RE: **Holly Senior Living**
9100 Holly Ave NE
Conceptual Grading and Drainage Plan
Engineer's Stamp Date: 10/17/18
Hydrology File: C20D079

Based on the submittal received on 10/23/18, this project cannot be approved for Site Plan Building Permit until the following are corrected and a complete resubmittal is made:

**CONCEPTUAL
GRADING AND
DRAINAGE PLAN**

SDP 3.1

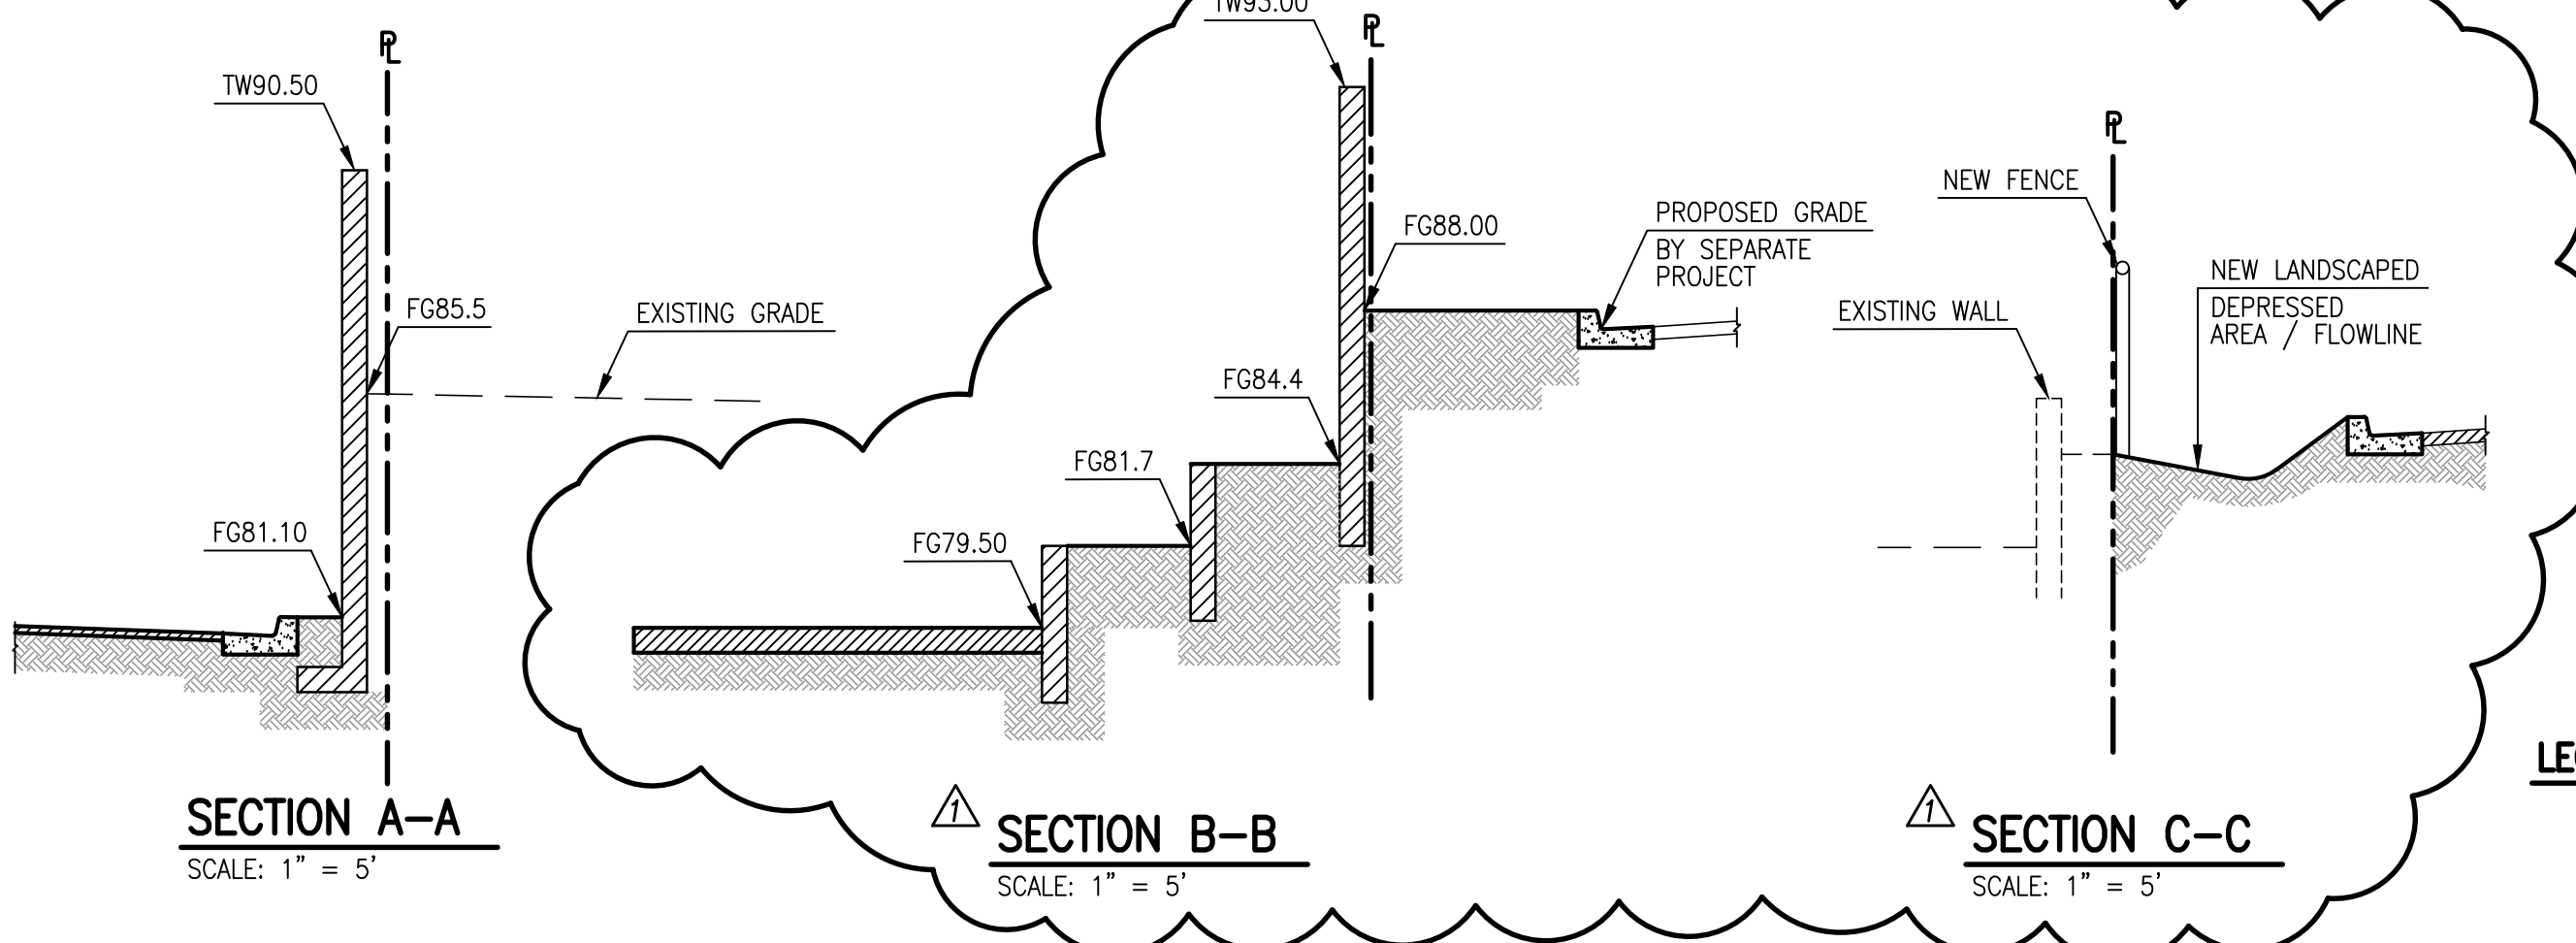
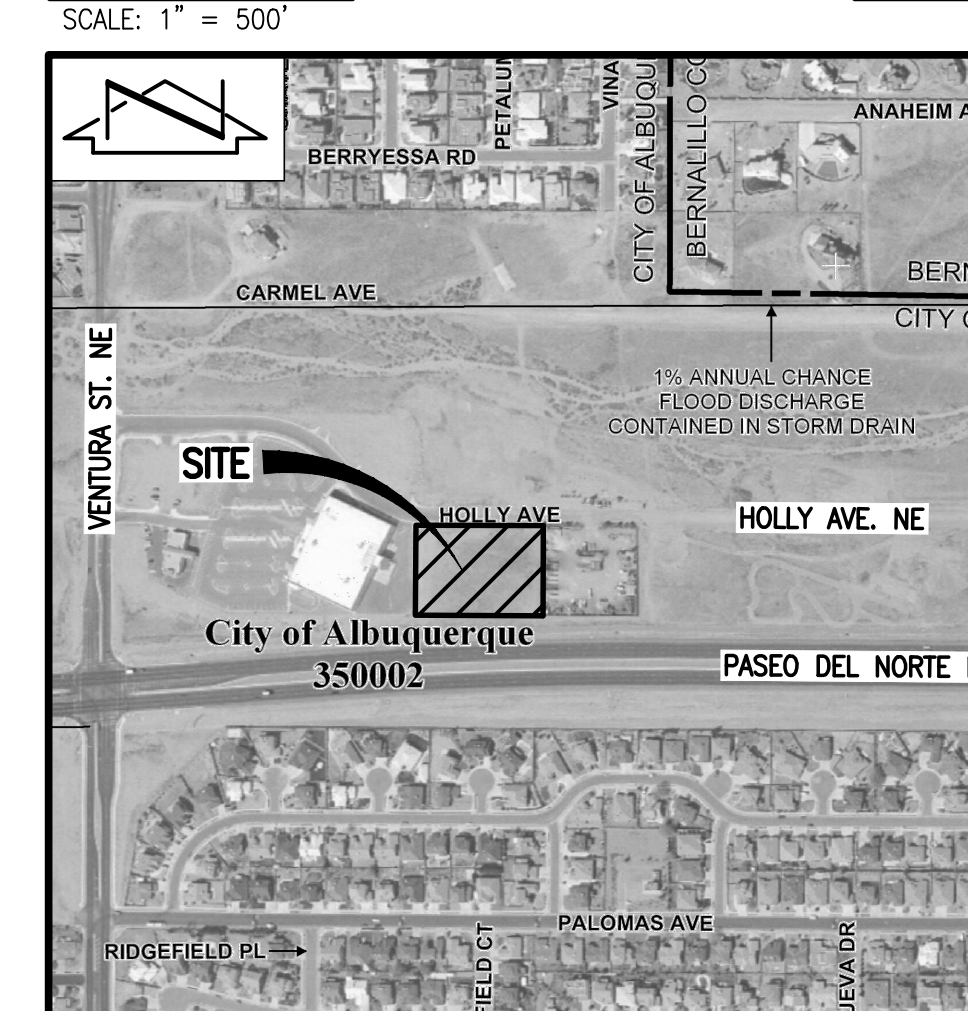
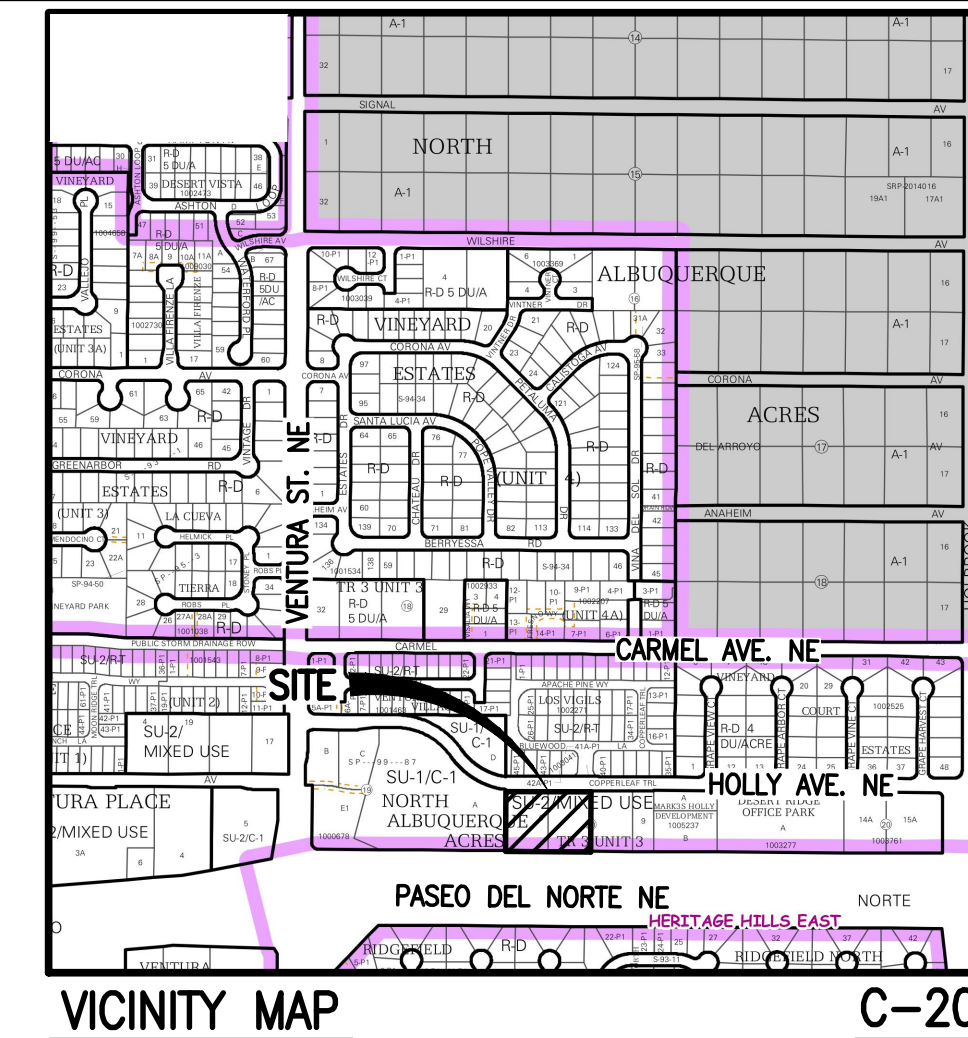
1. Provide structural drawings and calculations for the retaining walls at section B-B demonstrating that a wall with no footer will retain 3.6' of soil. Provide structural drawings and calculations for the retaining walls at section A-A demonstrating that the wall with reversed footer will retain 4.4' of soil. All structural drawings and calculations will need to be stamped by a structural engineer.

2. If the proposed retaining wall footer for Section B-B or Section A-A encroaches on the neighboring property; provide written permission from the adjoining property owner for this work. Written permission must include: signature of the property owner or owners representative, statement that undersigned is the owner or authorized representative, permission to construct the encroachment with a brief description of the encroachment.

3. Define the areas expected to route through first flush facilities and those that will bypass. State the first flush bypass volume on the plans.
